PRE-APPLICATION CONFERENCE

Timmen Landing Site Plan and Subdivision (2023-030-PAC)

Meeting conducted on Wednesday, August 30, 2023 – 2:00 P.M.

<p>substantial development permit and a shoreline conditional use permit. Critical areas in shoreline require review under the SMP.</p> <p>The site is located in a high-risk area for encountering archaeological resources and an archaeological predetermination is required.</p>
Date of Issue	September 8, 2023

Figure 1: WDFW Mapped Priority Habitat Species Areas

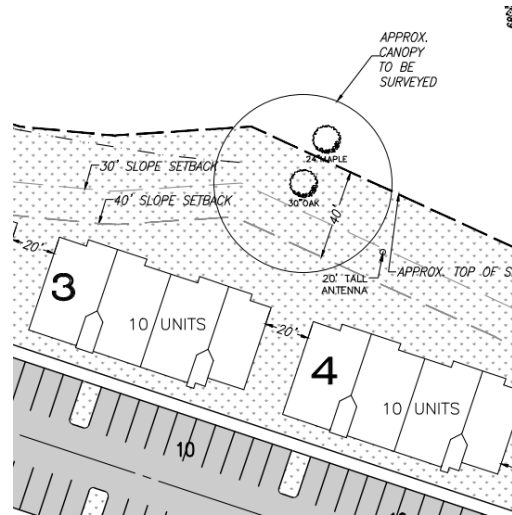
However, mapping by WDFW indicates an occurrence of Oak woodlands on the northern section of the project (see Figure X). The provided site plans and narrative also indicate a 30-inch Oregon white oak (Figure 1), which are a priority habitat and regulated by LCMC 18.300.090(2). Not all Oregon white oaks are considered priority habitat. Please see further WDFW guidance on this topic titled “Management Recommendations for Washington’s Priority Habitats: Oregon White Oak Woodlands” (WDFW, 1998) available on the internet through WDFW.

Any impacts to priority Oregon white oak habitat or its recommended protection area will require a critical areas permit. Oregon white oak habitat needs to be protected in coordination with WDFW guidance and meeting best available science (BAS). Typically, the City has required protection to the dripline of the oaks, but recent WDFW comments has request more protections to extend five to ten meters beyond the dripline. A qualified professional, either a biologist or an arborist, shall assess the habitat and write a critical areas report in accordance with LCMC 18.300.090(2)(d)(iii). A mitigation plan shall be provided in accordance with LCMC 18.300.090(2)(i) and demonstrate no net loss of the area or function of the priority habitat pursuant LCMC 18.300.090(2)(j).

Figure 3: Steep Slopes and Landslide Hazard Areas

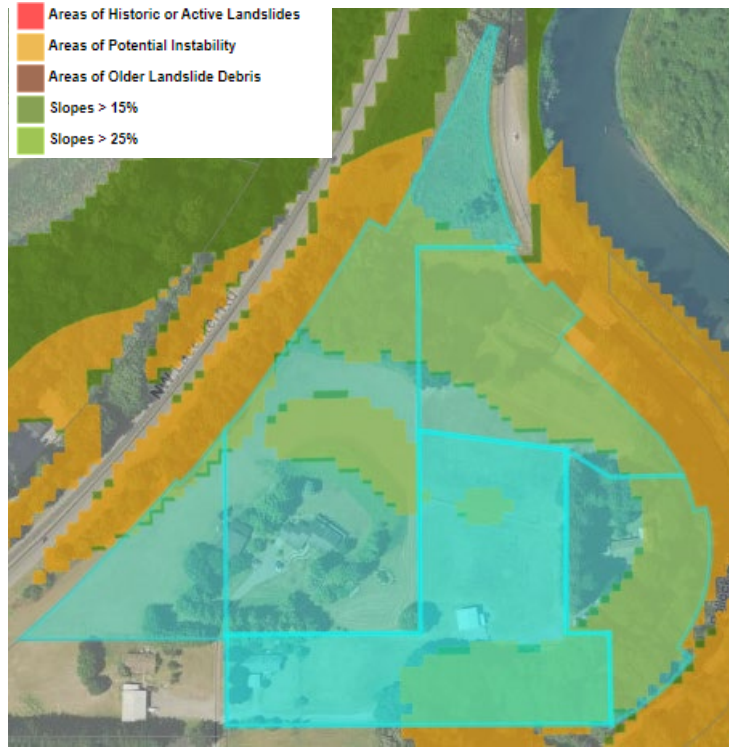
Figure 3 shows “areas of potential instability” that generally occur along the same area of steep slopes. These mapped areas are indicators of landslide hazard areas.

Development in or near landslide and erosion hazards must meet the requirements of City code including a 50-foot buffer from the edge of the landslide hazard which can be reduced to 25 feet upon the recommendation of the geotechnical engineer. Seasonal clearing restrictions apply in landslide and erosion hazards. Erosion hazard buffers are as recommended by a professional. Erosion control plans are required in erosion hazards.

Figure 5: NEHRP Site Classes

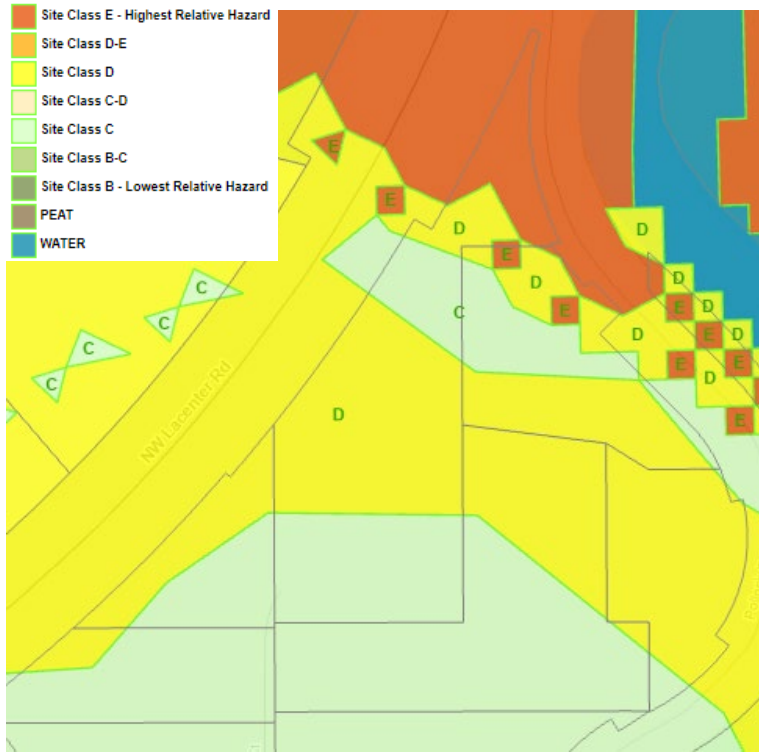
Figure 5 indicates there a National Earthquake Hazard Reduction Program (NEHRP) Site Class C, C-D, D, D-E, and E soils throughout the site. Therefore, seismic hazard areas likely exist on the site. Additionally, as shown in Figure 6, there are areas of moderate to high liquefaction susceptibility, which are also seismic hazard areas.

The applicant must provide a geotechnical engineering report documenting the geologic hazards and proposing mitigations to ensure that the development meets the requirements of LCMC

Figure 8: Urban Conservancy Shoreline Designation

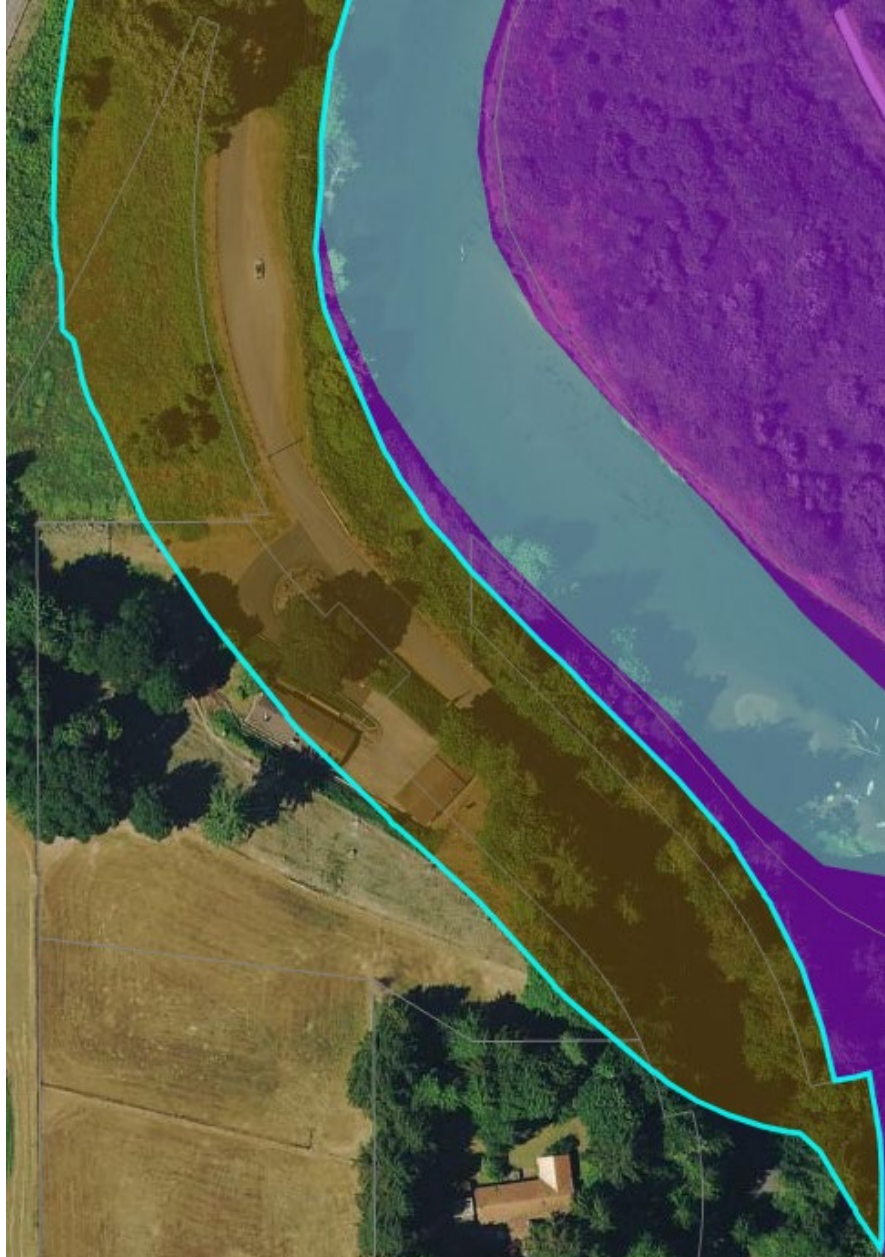
The City’s SMP applies to all lands within 200 feet of ordinary high-water mark of shoreline waterbodies and to associated wetlands of these waters. The East Fork of the Lewis River is a shoreline waterbody. The northern edge of the site is located in the Urban Conservancy designation (Figure 10) meant to “protect and restore ecological functions of open space, floodplains, and other sensitive lands where they exist alongside urban and developed settings. The applicant is possibly proposing to locate stormwater infrastructure (detention, treatment, and outfall) or an open space area in shoreline jurisdiction. Stormwater infrastructure is considered to be a utility use and requires the approval of a shoreline substantial development permit (SSDP) and shoreline conditional use permit (SCUP). In addition, development of stormwater facilities in shoreline jurisdiction must be designed to mimic natural wetlands. An open space area is considered a recreational use and would require an SSDP. A water-related/enjoyment use such as trails or accessory buildings are a permitted use whereas non-water-oriented uses such as golf course or sports fields require an SCUP. The SCUP would require final review and approval by the Washington Department of Ecology (DOE) in a 30-day period following City review.

- Archaeological resources must be protected per Section V.B
- Critical areas within shoreline jurisdiction are subject to review under Appendix B of the SMP and Section V.C. The critical areas provisions are largely the same as outside shoreline jurisdiction.
- Public access to the shoreline must be provided in accordance with Section V.E

- Vegetation in shoreline jurisdiction must be preserved onsite or replaced elsewhere within shoreline jurisdiction onsite per Section V.H.
- Utility uses constructed parallel to the shoreline (detention and treatment) must be setback a minimum of 100 feet from the ordinary high water mark of the river while the outfall (a perpendicular utility) does not require a setback.
